# **Consideration of Comments**

Project 2010-13.3 – Phase 3 of Relay Loadability: Stable Power Swings

The Stable Power Swings Drafting Team thanks all commenters who submitted comments on the standard. This standard was posted for a 45-day public comment period from April 25, 2014 through June 9, 2014. Stakeholders were asked to provide feedback on the standard and associated documents through a special electronic comment form. There were 70 sets of comments, including comments from approximately 181 different people from approximately 117 companies representing all 10 Industry Segments as shown in the table on the following pages.

## Example: Hydro-Quebec 735 kV network

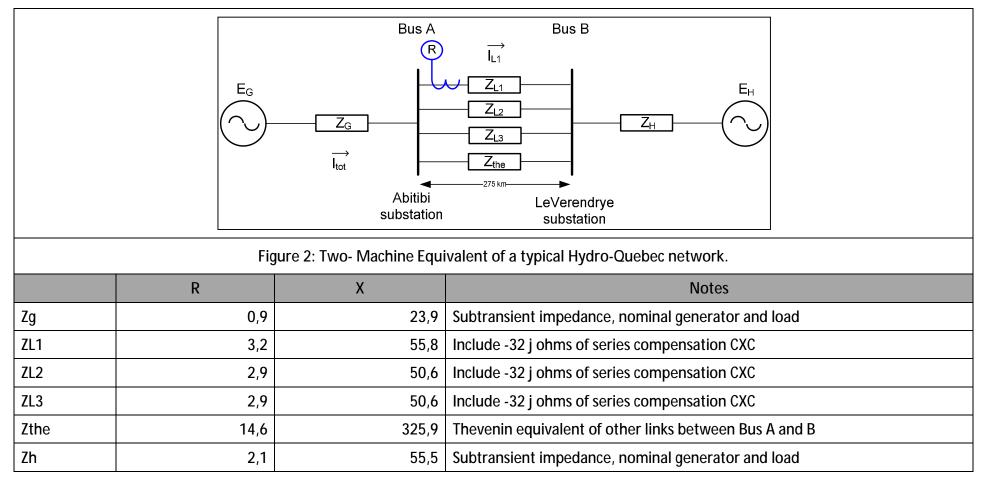
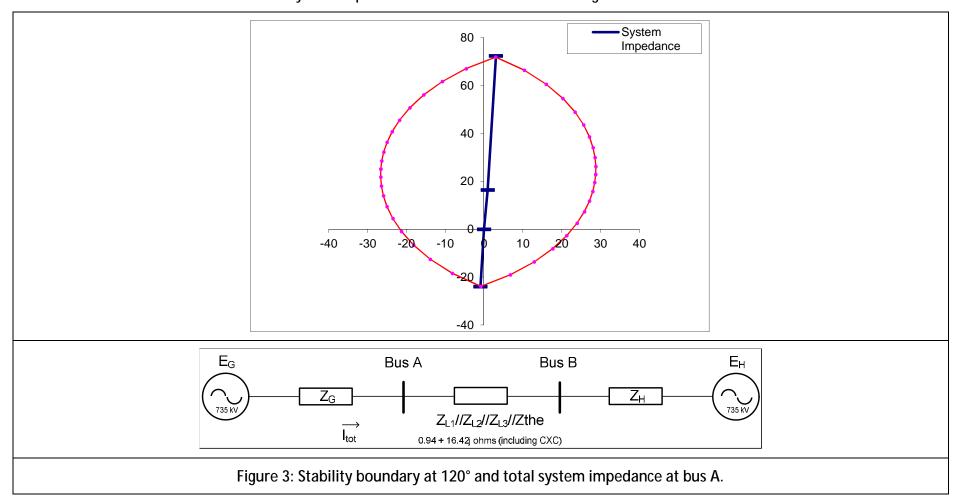
Typical Hydro-Quebec network configuration is 3 parallel 735 kV lines connecting into 2 substations. See figure below.

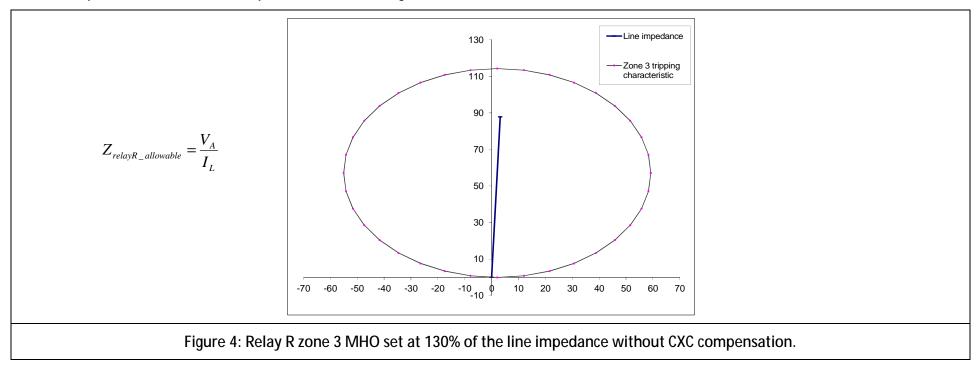
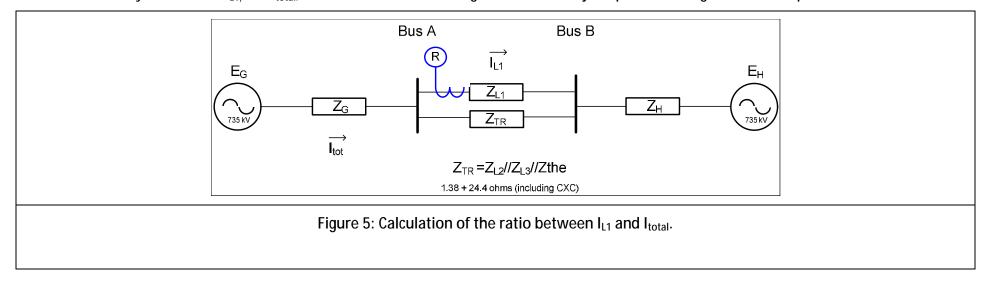
The 120° lens characteristic and the total system impedance at bus A are drawn at the figure below.

Typical 735 kV lines are protected by main A and main B current differential protections. Back up distance protection is also used. This distance protection is subject to PRC-026 and need to be evaluated. The larger tripping element of this protection is typically a zone 3 MHO set at 130% of the line impedance without CXC compensation. See next figure.

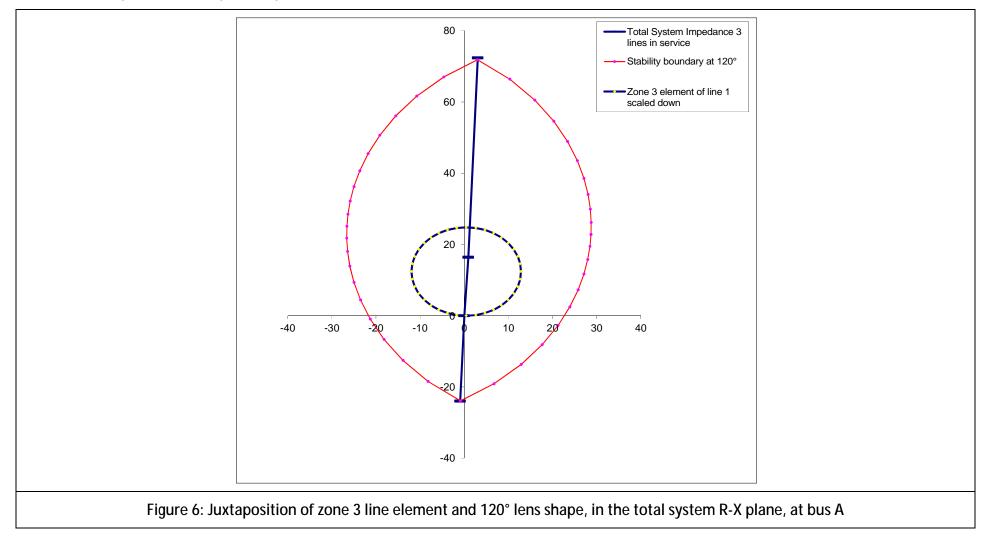
This distance relay R measures I<sub>L1</sub>, not I<sub>total</sub>. The distance element of figure 4 cannot be juxtaposed with figure 3 lens shape.

The distance relay measures 1/4.6 of the total system current. Therefore, the zone element of the line 1 is divided by 4.6 before being juxtaposed with the total system boundary stability.

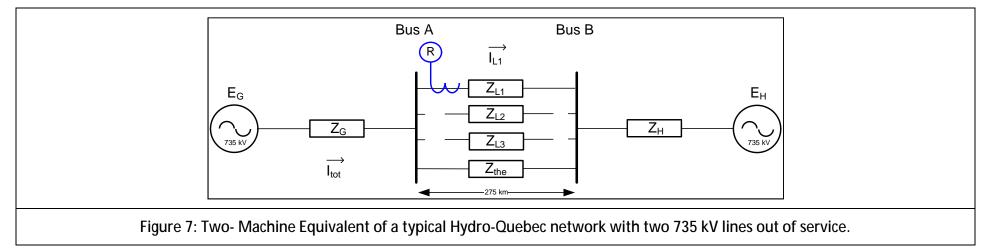
The MHO 130% elements is clearly inside the 120° lens characteristic. With three735 kV lines interconnecting bus A and B, power swings are unlikely to occur. As mentioned by the SPCS power swing report, considering all the parallel transfer impedance is more accurate and allows a greater relay reach.

The 735 kV Hydro-Quebec is more likely to swing when two of the three 735 kV lines are out of service. PRC-026 R3 doesn't impose to evaluate this case. However, it's an interesting topology to study.

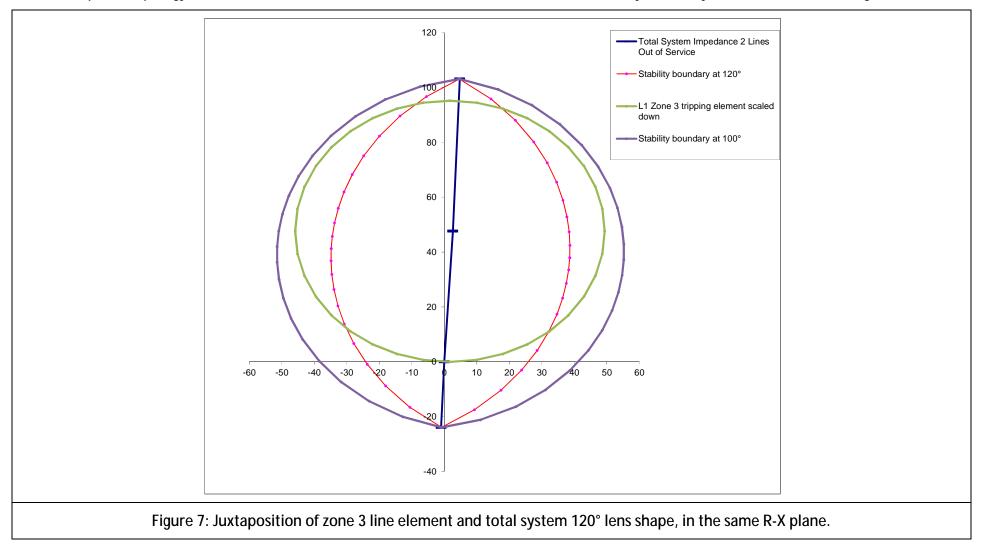
Here, the transfer impedance is increased approximately by three. The line current  $I_{L1}$  measures by the relay R is almost equal to the total system current  $I_{total}$ .

The scale factor is reduced:

$\frac{\left(Z_{L1} + Z_{TR}\right)}{Z_{TR}} = 1.2$

With this special topology, the MHO Zone 3 element is no more contain within the 120° stability boundary, as shown at the next figure.

The total system impedance of figure 7 can only exist for a maximum of 20 cycles. Zone 3 is a delayed tripping element of 30 cycles. It can be assumed that it won't trip in this condition. As allowed by PRC-026-R3, maybe a reduced stability angle could be used to evaluate this particular topology. The last figure shows that the zone 3 tripping element is within a 100° lens shape.
